FINAL SITE GRADING CONSTRUCTION PLANS  
FOR  
**CARRIAGE MEADOWS SOUTH at LORSON RANCH**  
FINAL GRADING / EROSION CONTROL PLANS

**COVER SHEET  
FINAL SITE GRADING  
AND EROSION CONTROL PLANS**

DATE  
**JUNE 20, 2017**  
PROJECT NO.  
**100.030**  
SHEET NUMBER  
**C0.1**  
TOTAL SHEETS: **17**

**SF 17-011**

**STORM SEWER LINE A (DISTRICT)  
 CARRIAGE MEADOWS SOUTH  
 FINAL GRADING PLAN**

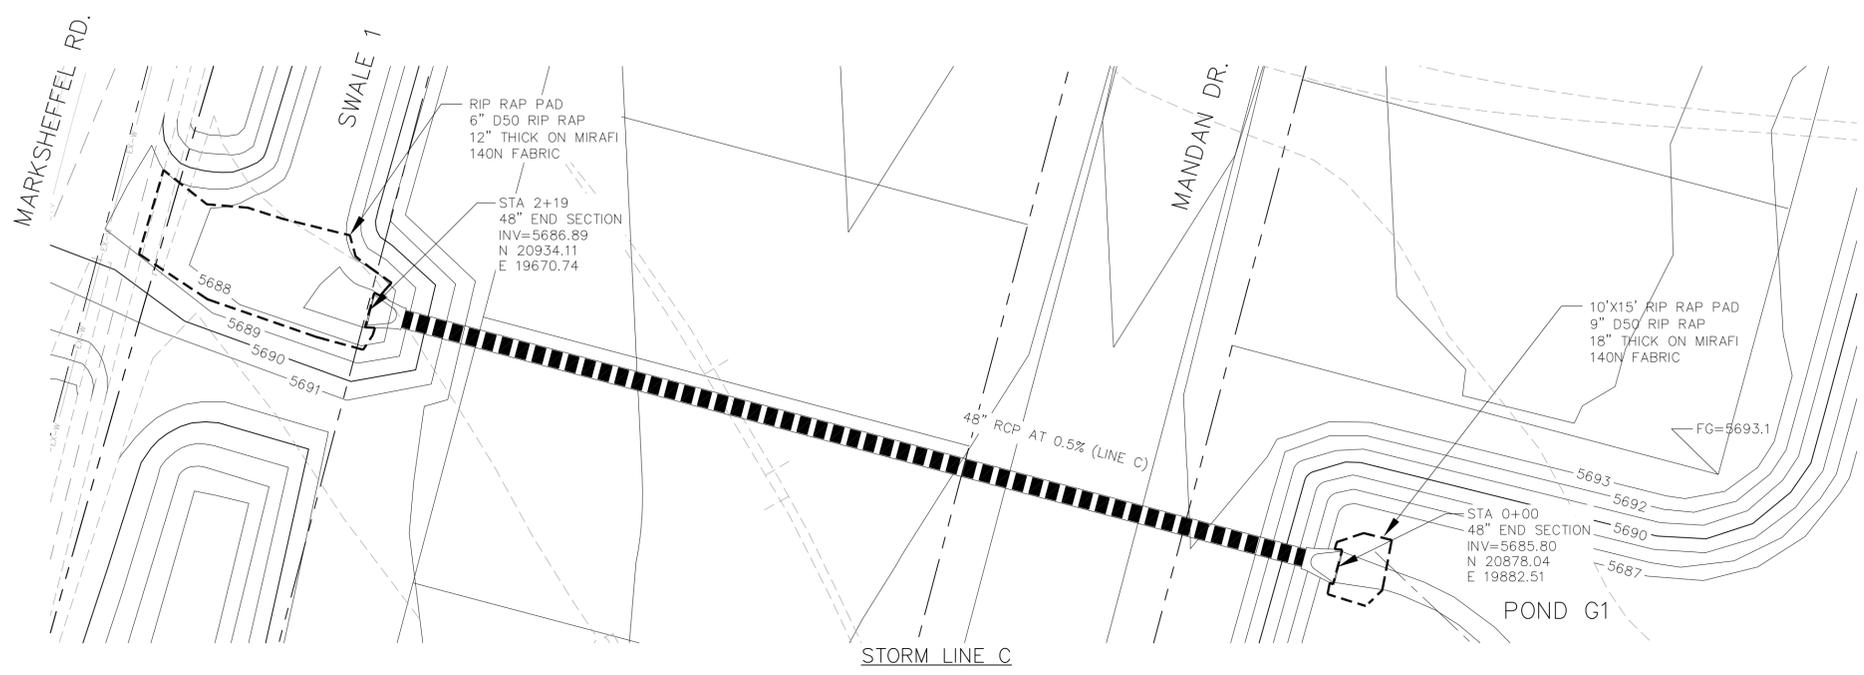
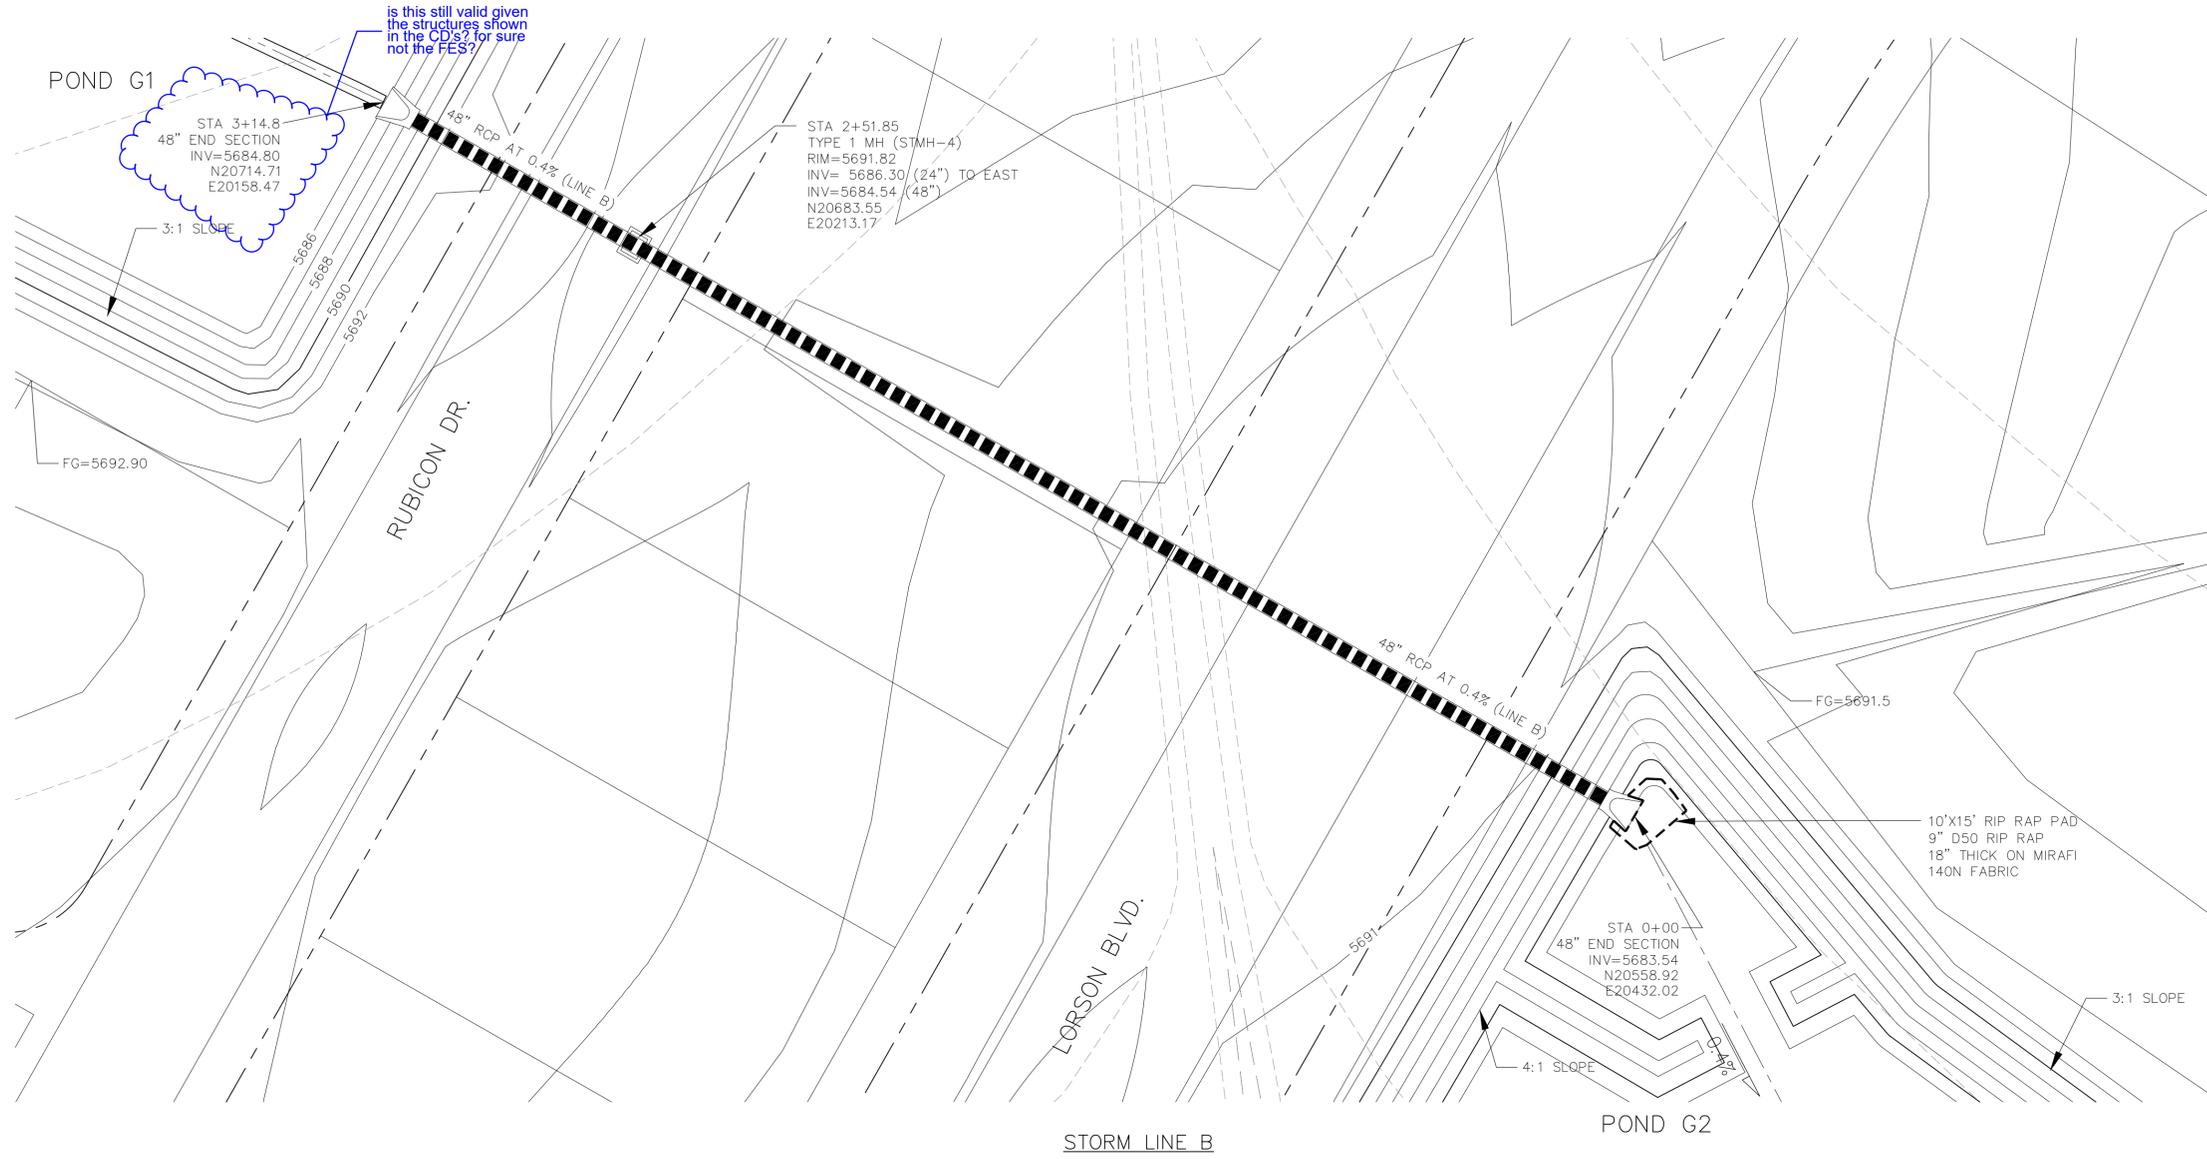
Please confirm compliance with section ECM 3.3.1, angle of confluence.

DATE	JUNE 20, 2017
PROJECT NO.	100.030
SHEET NUMBER	C4.13
TOTAL SHEETS:	17

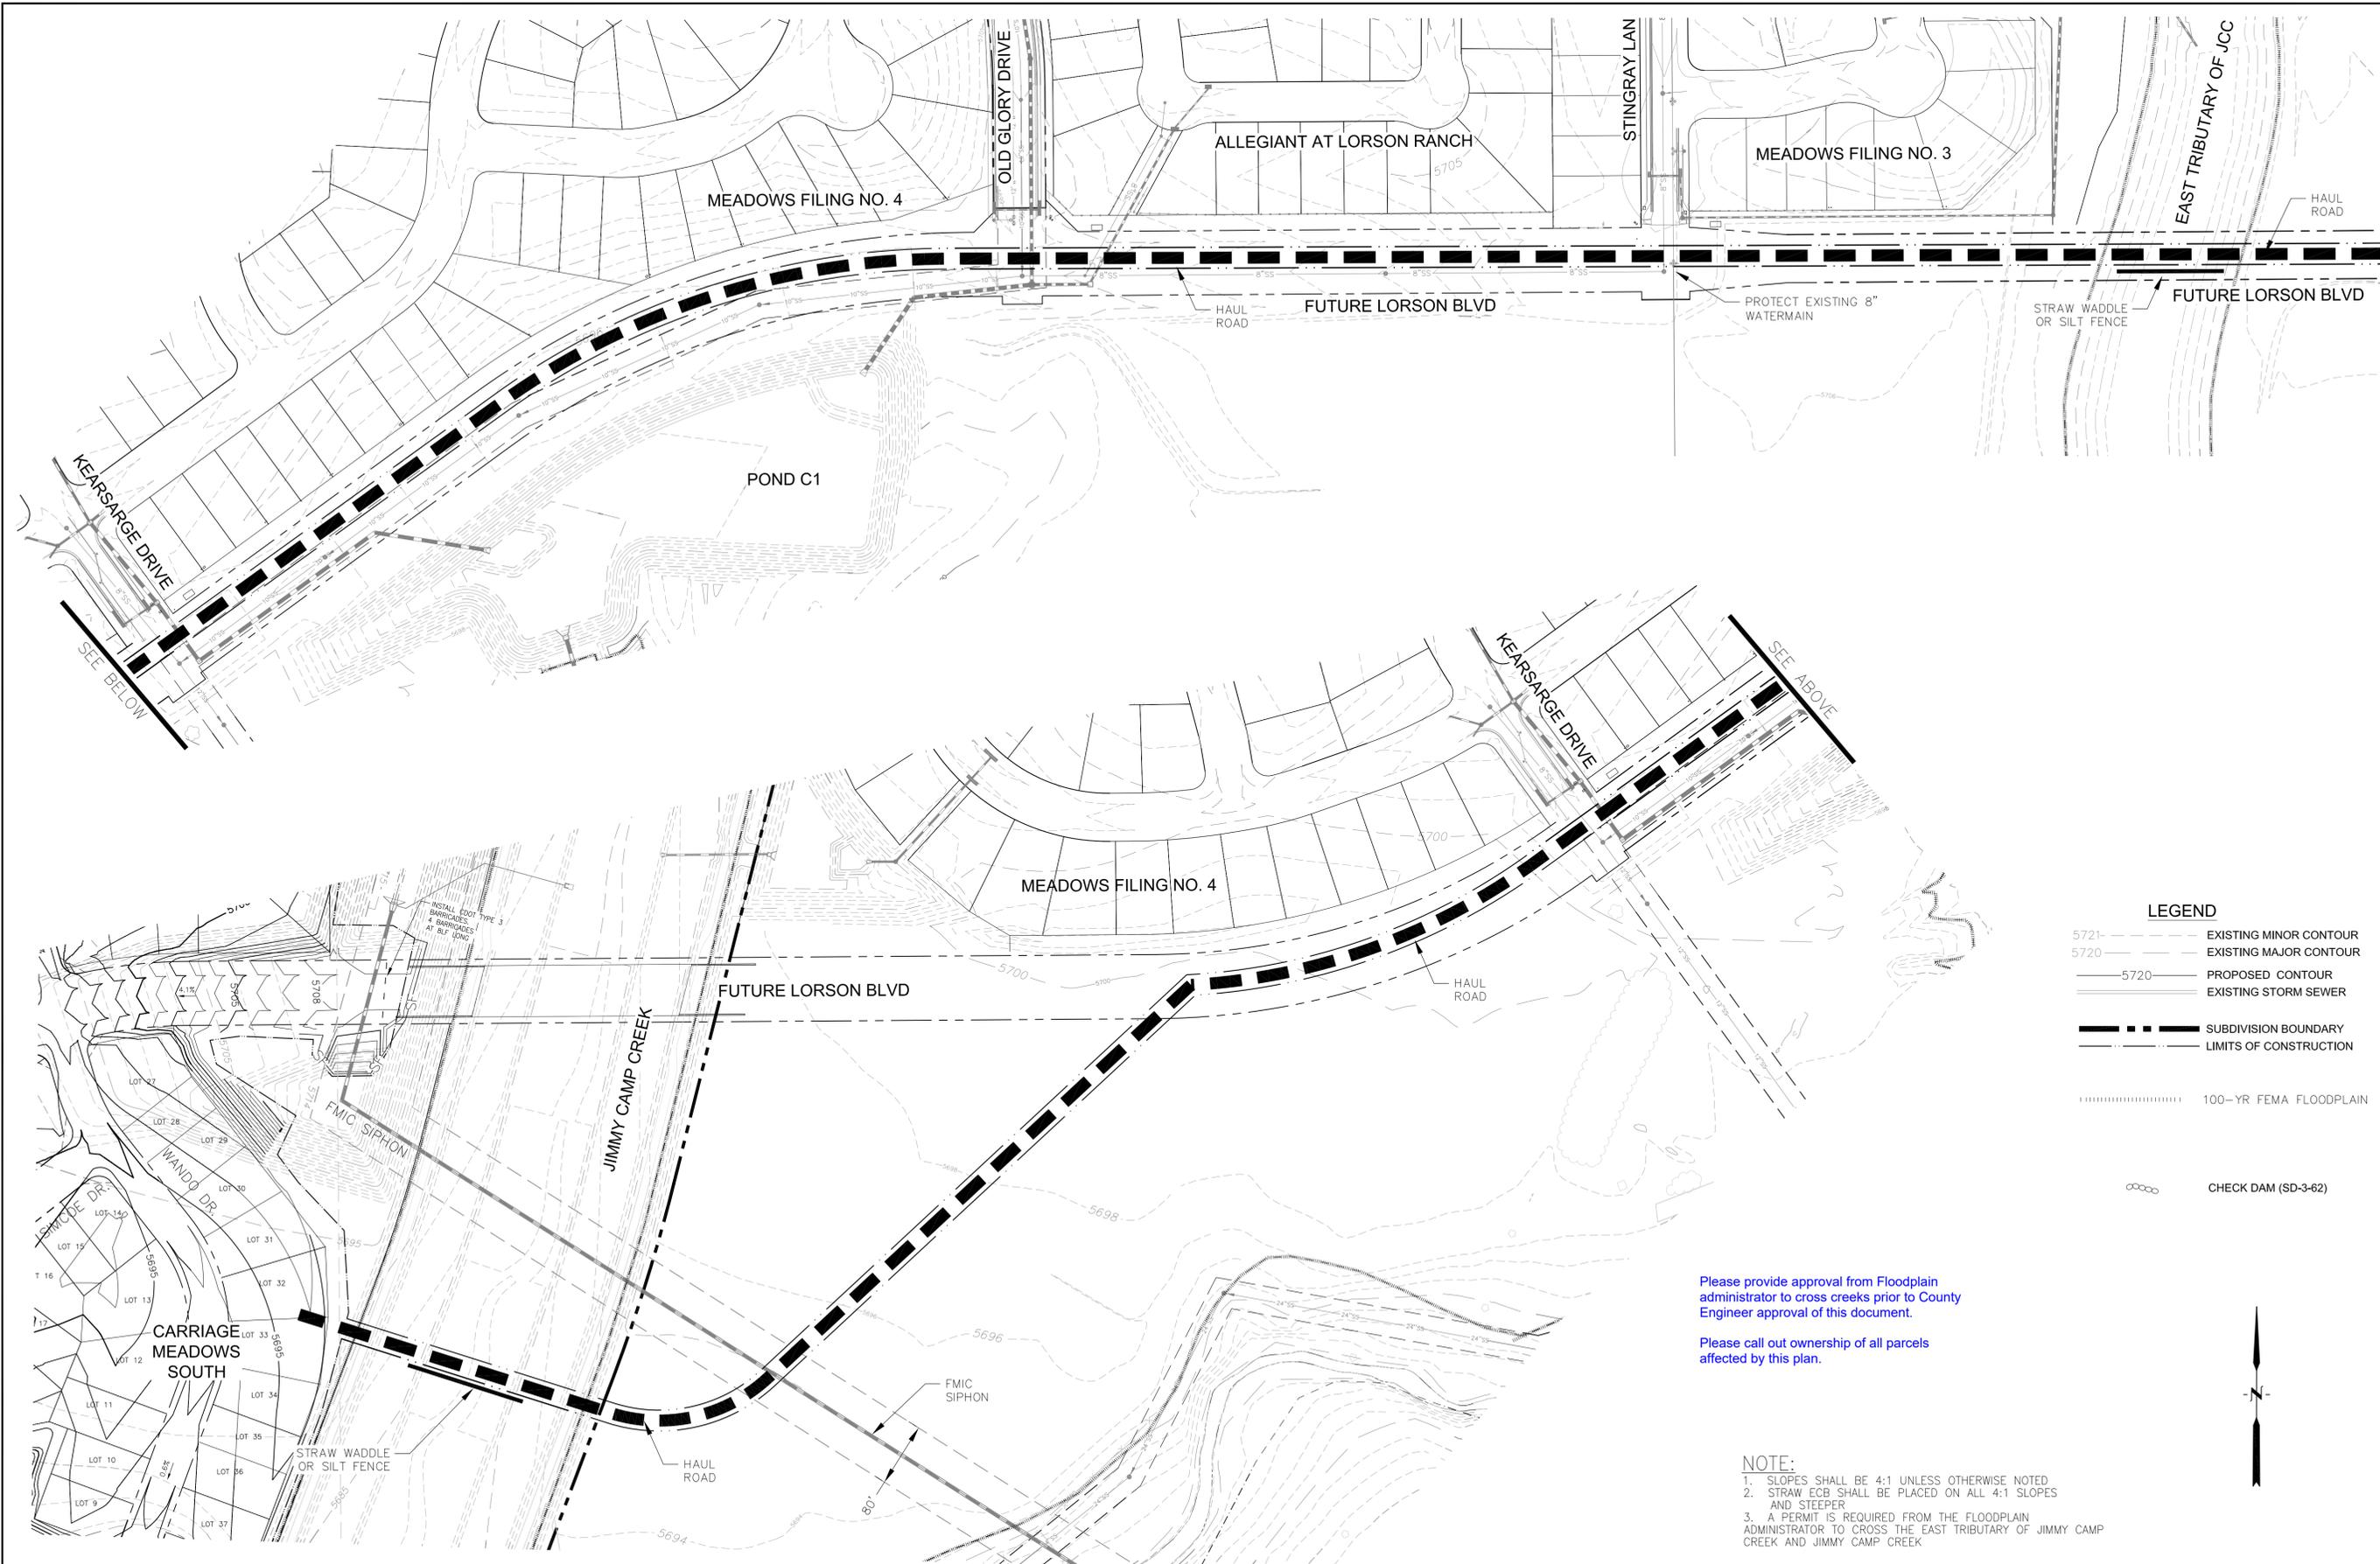
Please provide approval from Floodplain administrator to cross creeks prior to County Engineer approval of this document.

Please call out ownership of all parcels affected by this plan.

**CARRIAGE MEADOWS SOUTH  
 FINAL GRADING AND E.C. PLAN  
 OFFSITE BORROW AREA**

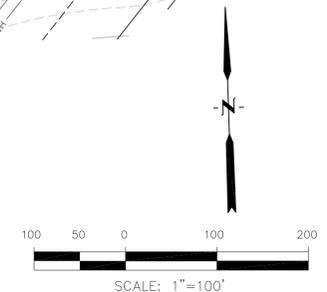
please call out ownership of the parcel containing the borrow area and the haul road.
